ITEM FOR ENVIRONMENTAL COMMISSION AGENDA

NAME & NUMBER OF PROJECT: Water Oak Apartments
SP-2019-0109C

REQUEST: Variance request is as follows:

- Request to vary from LDC 25-8-342 to allow fill to 25 feet to construct a driveway.

CUTFILL EXHIBIT

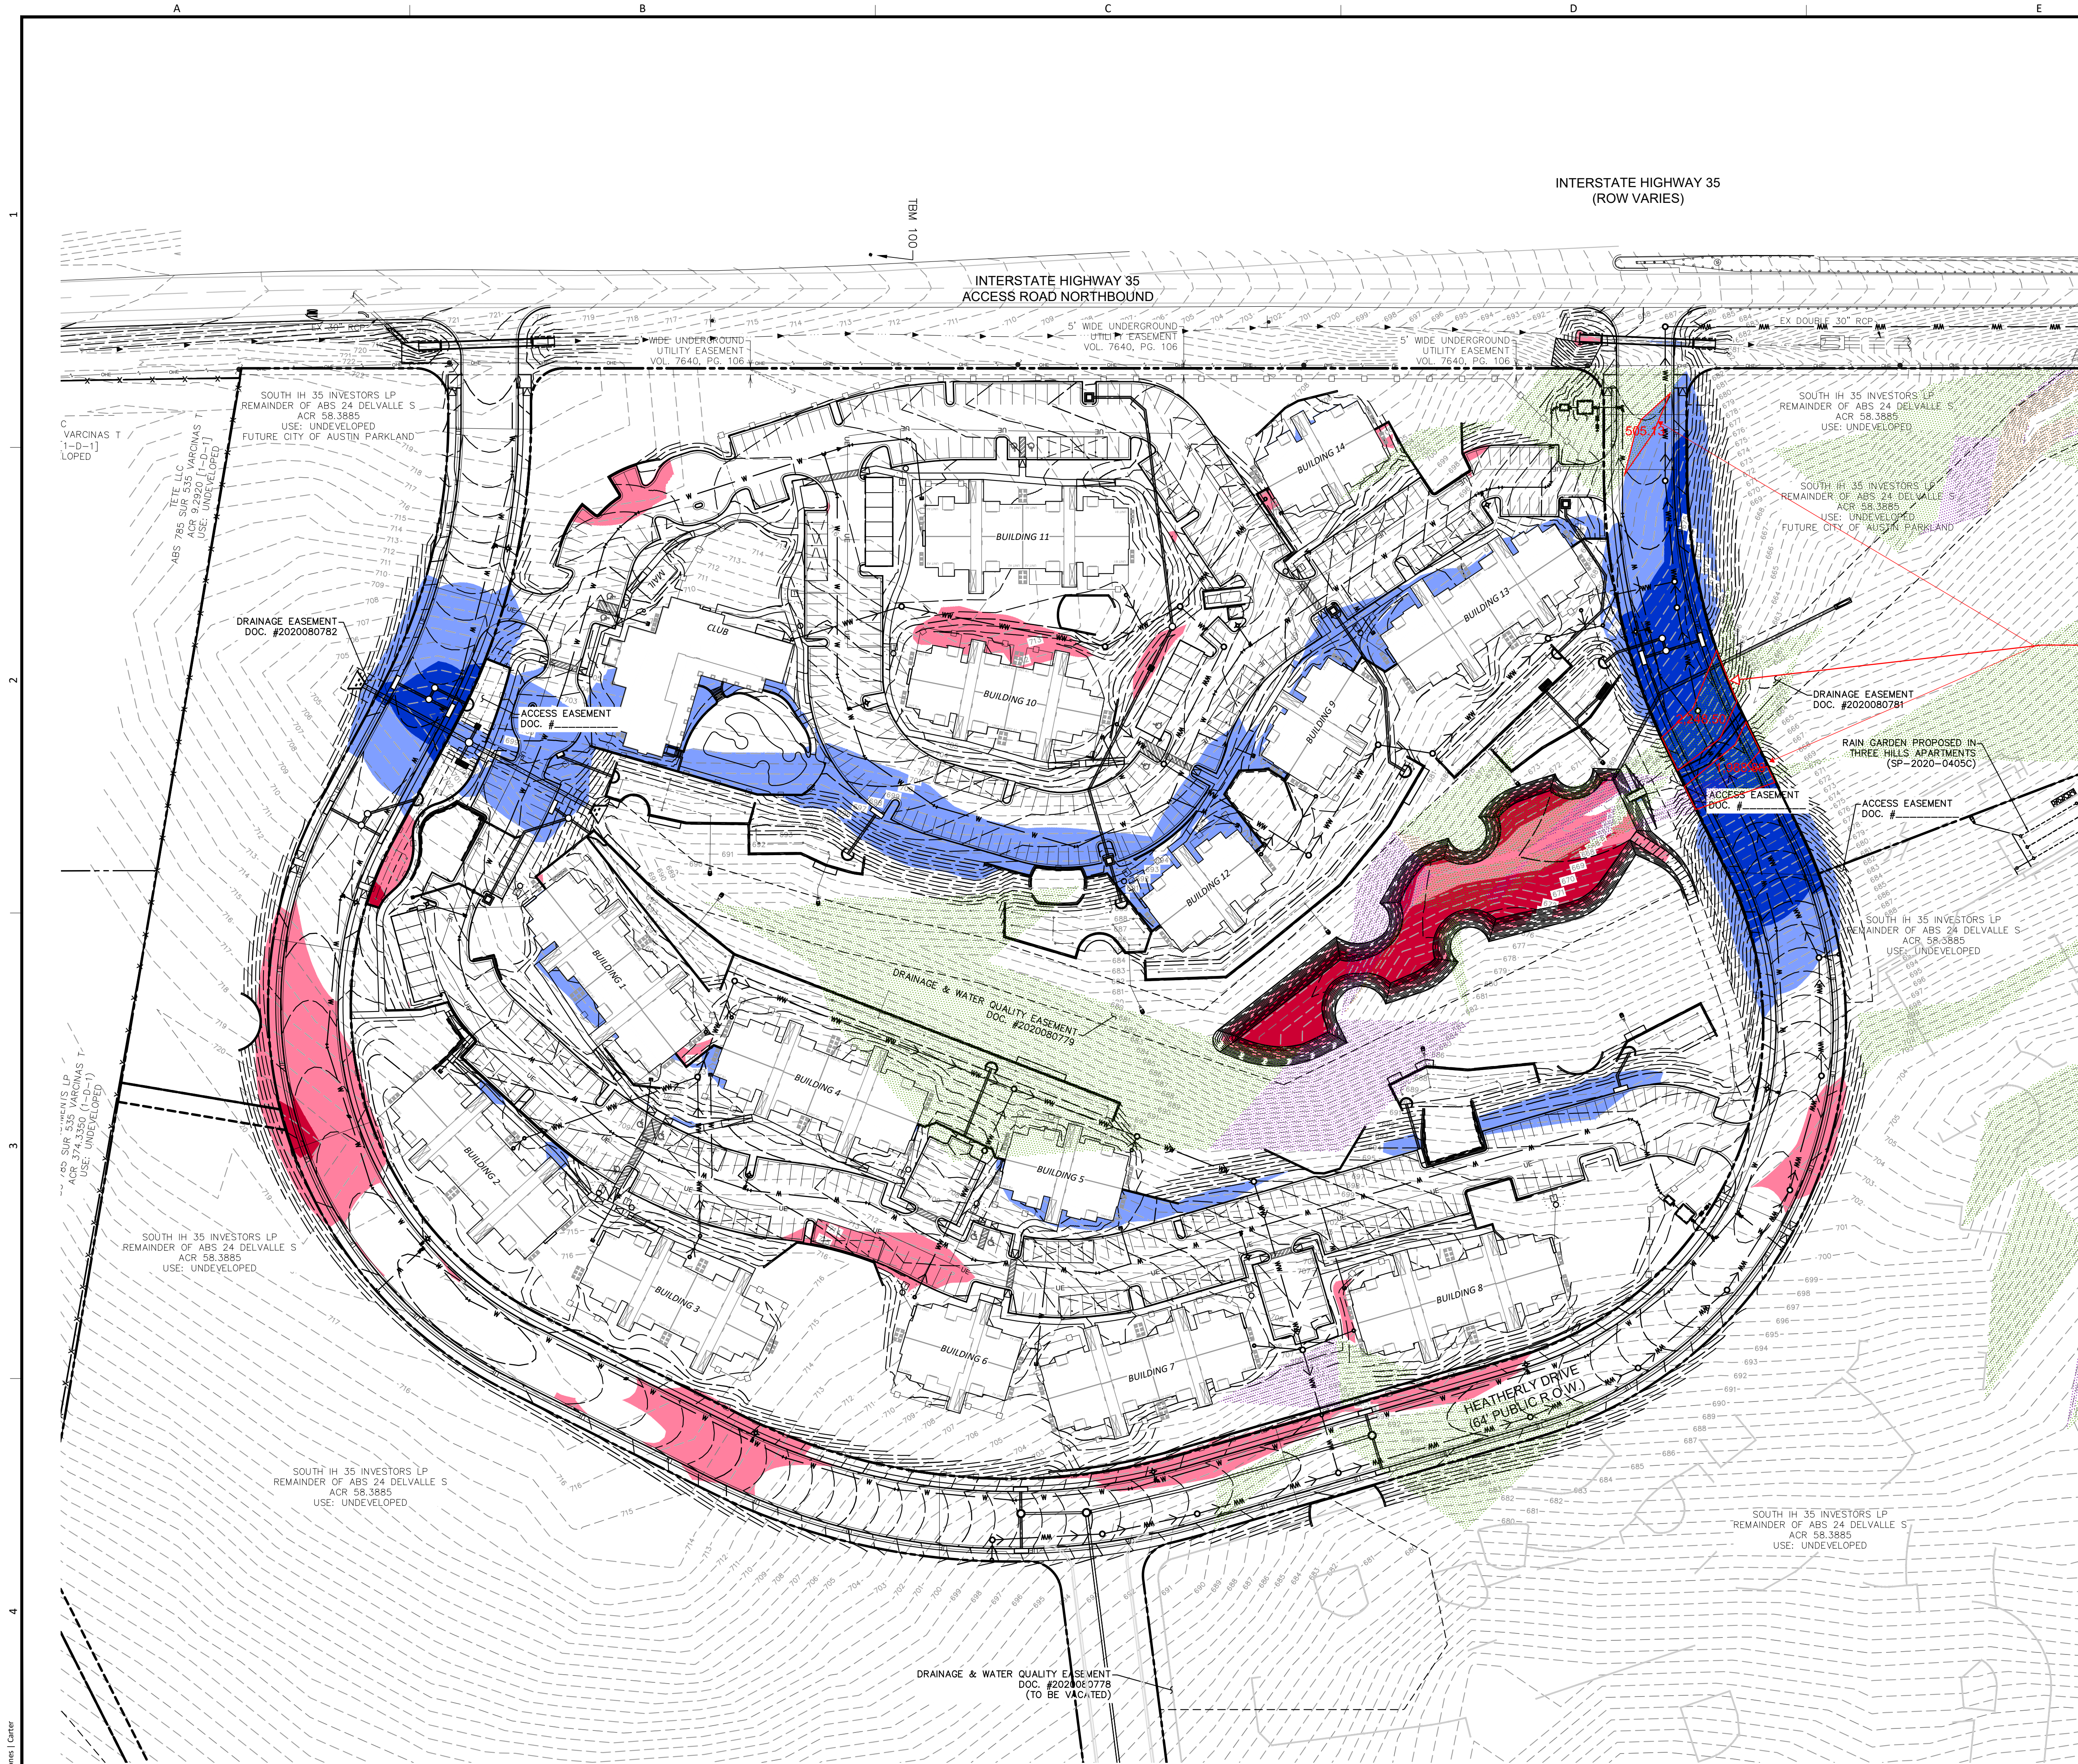
No The variance is necessitated by the construction method chosen by the applicant. The depth and quantity of fill is due to the applicant's decision to fill rather than span the more than twenty (20) feet of grade change of the swale.

No The property is a seven-lot, 58.4 acre subdivision with 40.9 acres platted for multi-family development. The code

requirements do not deprive the owner of reasonable use of the property.

0.11 Acres Fill
Over 4' in 15%
Slope Zone
